January 19, 2016

William Teuscher, PE
Department of Environmental Quality
900 N. Skyline Dr., Suite B
Idaho Falls, Idaho 83402

Re: Addendum No. 2 to Elk Bend Facility Planning Study

FIGURE 1

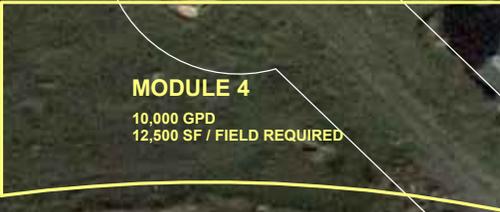
We expect to design four disposal modules with each taking up to 10,000 gallons/day. With this plan, the attached preliminary design layout of the LSAS yields four beds of 12,500 sq. ft. each. The sizing calculation for each module is attached. This layout will need a variance in regards to property line set backs and allowance to construct a small part of the LSAS within the 100 year flood plain of the Salmon River. We don't see either of these as being harmful to neighbors or the environment. The approximate location of the 100 year flood plain line is shown on the attached map of the LSAS site. With these allowances, this site will be an adequate disposal area.

Per discussions with DEQ, a disposal bed will be allowed. Thus four beds of 12,500 sf will be required and two additional beds for future set-aside.
